**CITY OF BEND PLANNING DIVISION
TYPE II ADMINISTRATIVE REVIEW AND DECISION**

PROJECT NUMBER: PLLD20220552 (Tentative Plan)

REQUEST: A Type II Tentative Plan application for a 35-lot residential
subdivision in the Residential Standard Density (RS) Zone. The
property is approximately 7.65 acres in size.

2 TENTATIVE PLAN
TP1.0 SCALE: 1" = 100'

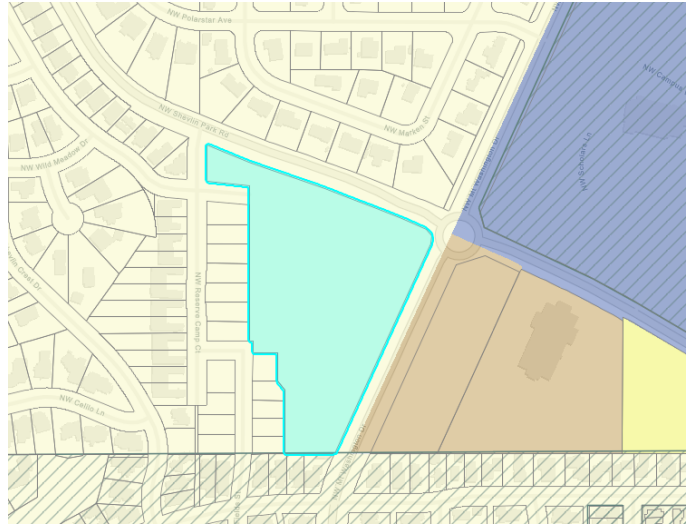
The property does not contain any watercourses or water rights. The Site does contain two rock outcropping areas. As depicted on the Tentative Plan, an existing outcrop, identified as OC A, is 13,823 square feet and is located on the western edge of the Site between Northwest Summerhill Court and Tract C. The second existing outcrop area, identified as OC B, is 5,353 sq. ft. and is located north of Tract C and west of proposed Lots 39 and 40. OC A and OC B are not included in the boundaries of the surrounding single-unit lots. Therefore, the rock outcropping areas as well as all vegetation including trees within these areas will be protected.

FINDING: The subject property does not contain any watercourses. The property does contain two rock outcropping areas. As depicted on the Tentative Plan, an existing outcrop, identified as OC A, is 13,823 square feet and is located on the western edge of the Site between Northwest Summerhill Court and Tract C. The second existing outcrop area, identified as OC B, is 5,353 sq. ft. and is located north of Tract C and west of proposed Lots 39 and 40. OC A and OC B are not included in the boundaries of the surrounding single-unit lots. Therefore, the rock outcropping areas will be protected and each proposed dwelling unit lot meets the minimum standards and has adequate room for development. Therefore, increased lot sizes are not required to allow adequate room for development and protection of significant topographic or natural features.

FINDING: The proposed subdivision is an infill project. The subject property abuts NW Shevlin Park Road right-of-way to the north and NW Mt. Washington Drive to the east. Both roadways are designated minor arterial streets per the Bend Transportation Plan. The proposed subdivision includes an east-west extension of NW Summerhill Drive, extending from the stubbed connection approved through Phase 1 through the property to connect with NW Mt Washington Drive at an existing driveway access point on the east edge of the property creating a through street. As detailed in the Transportation Facilities Report prepared by Transight Consulting, the proposed connection onto NW Mt Washington Drive meets the distance requirements for site access onto an arterial. The proposed block length between NW Reserve Camp Court and NW Mt. Washington Drive is approximately 900 square feet. The proposed block perimeter is approximately 2,500 square feet. Given the proximity to the existing roundabout at the intersection of NW Mt. Washington Drive and NW Shevlin Park and considering that both abutting streets are designated minor arterial streets, further street connects that would allow the project to meet site connection and access requirements for arterial roadways are not possible. For these reasons, this standard is met to the greatest extent possible.
